REMARKS

II. OBJECTION TO THE DRAWINGS

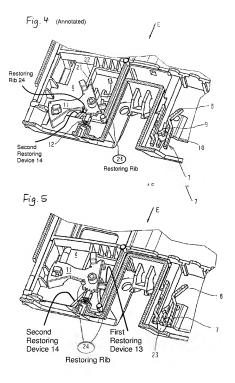
The Examiner objects to the drawings as failing to show how restoring rib 24 rides over the second restoring device 14 in order to maintain the mass 11 in the position shown in Figure 2. The Examiner refers especially to a figure showing the receptacle in the open position detailing the position of the safety locking mechanism with respect to the housing, as described in the specification.

As is shown in Figs. 4 and 5 of the present application, reproduced below, the drawings do in fact illustrate how the restoring rib 24 rides over the second restoring device 14. For the Examiner's convenience, the figures as shown herein have been annotated to include the specific callouts for the restoring rib 24 and the second restoring device 14 consistent with that shown in the other figures. Fig. 4 illustrates the mass 11 in the deflected position. Fig. 5, on the other hand, shows the mass 11

restored to the basic position (of Fig. 2) as a result of the restoring rib 24 riding over the second restoring device 14 and coming into contact with the first restoring device 13.

Consequently, applicant respectfully submits that the drawings already show how the restoring rib 24 rides over the second restoring device 14 in order to maintain the mass 11 in the position shown in Fig. 2.
